Docket Nos.: 50-361
and 50-362

FACILITY: SAN ONOFRE NUCLEAR GENERATING STATION, UNITS 2 AND 3

SUBJECT: SUMMARY OF SAN ONOFRE MEETING ON AUXILIARY FEEDWATER SYSTEM

NRC AUXILIARY SYSTEMS BRANCH REVIEW
MAY 15, 1980

(FIG. 4)

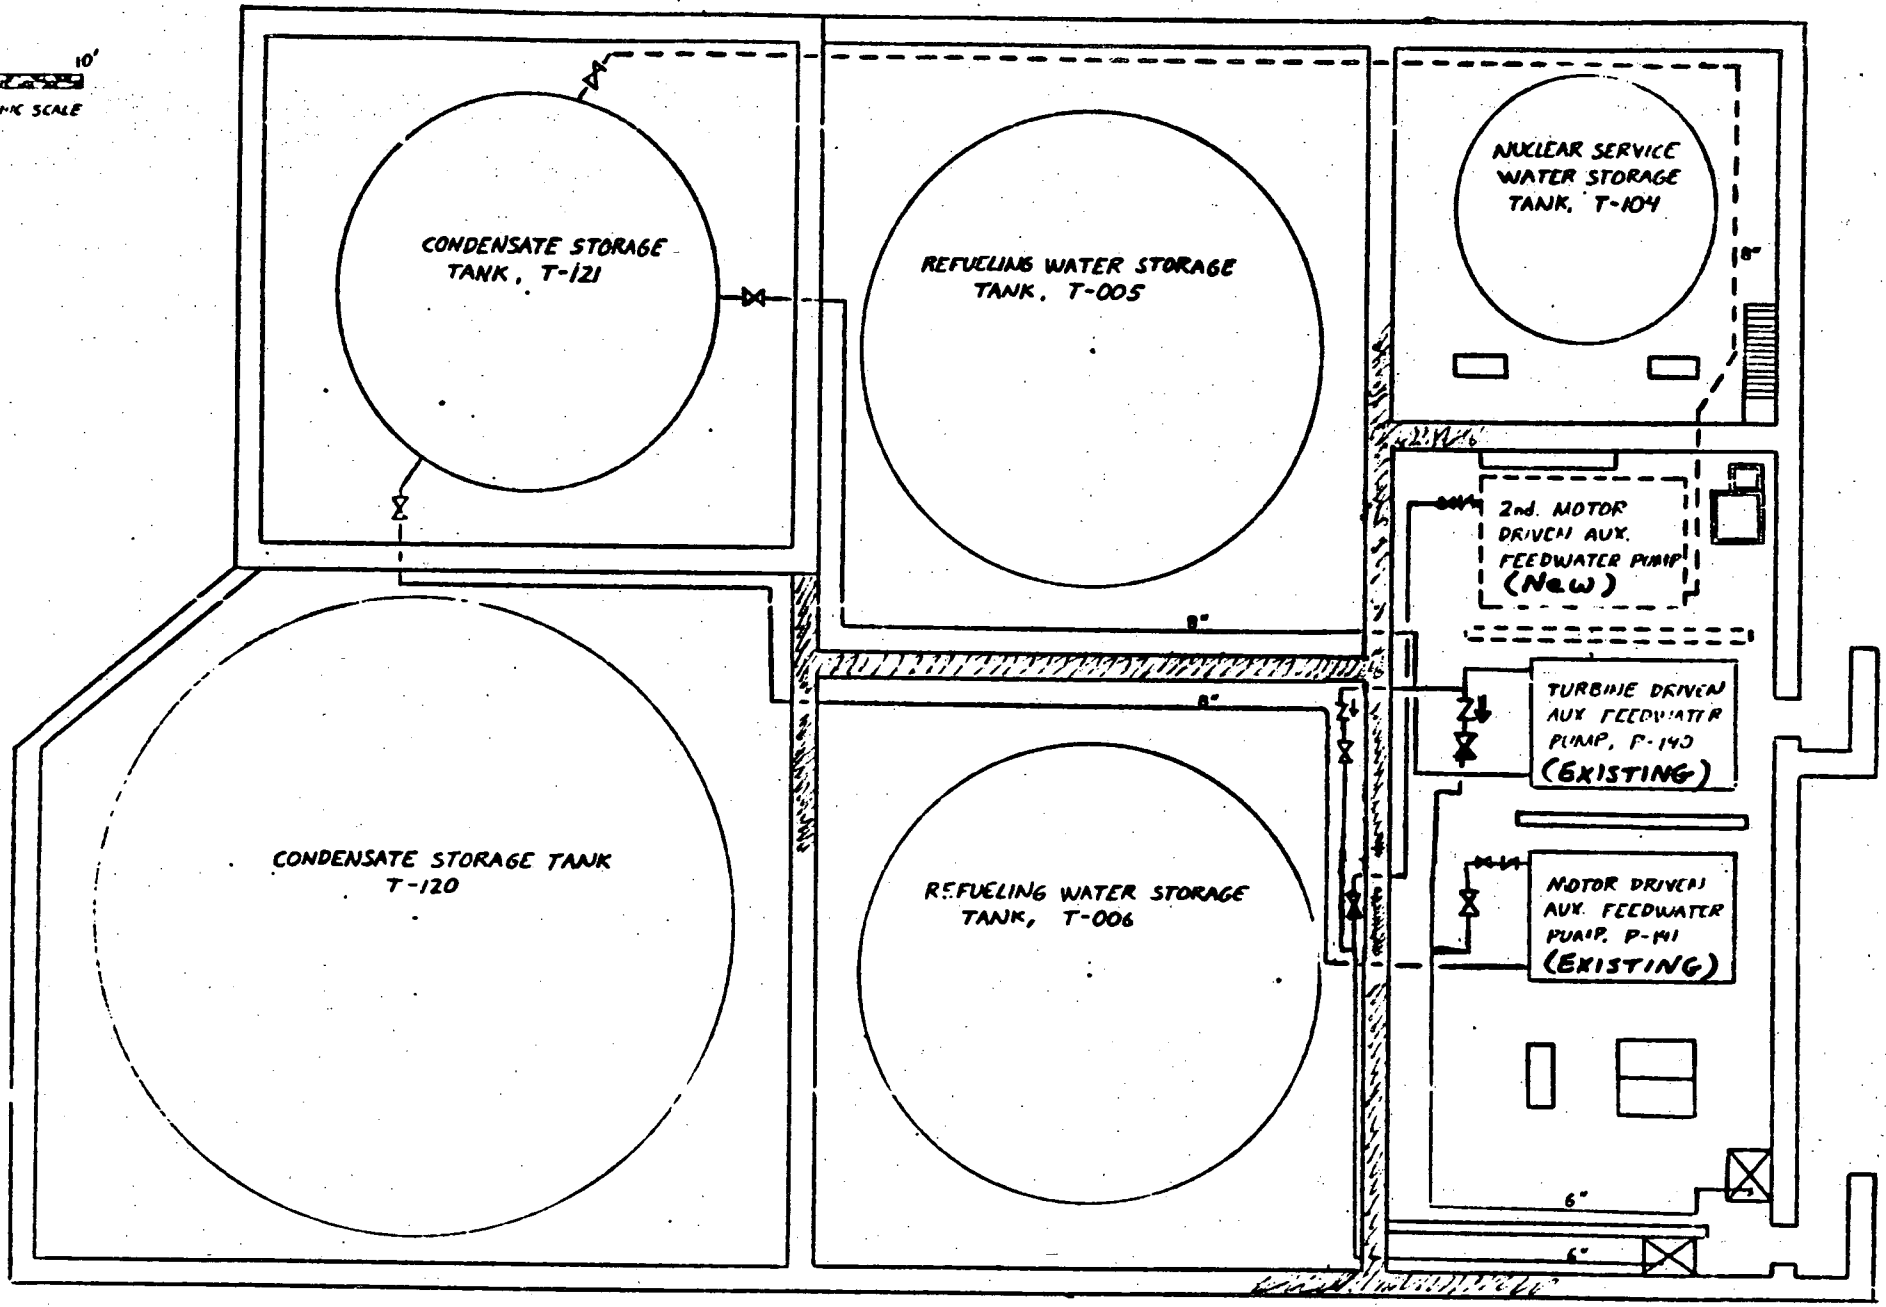
Much of the discussion at the meeting involved agenda item II, post-seismic condensate storage capacity. The basic problem is that some water from the 500,000 gallon, non-seismic, condensate storage tank (see Figure 4 of Enclosure 3) will be needed to cool the plant down to 3500F, following a postulated SSE and the worst single failure (reference questions 010.65 and 212.139). Various approaches to the problem were discussed, including (1) showing that the Category I tank building can contain sufficient water for the required time or (2) providing a backup source of salt water. The applicant agreed to evaluate the various options and propose a method of solution in the near future.
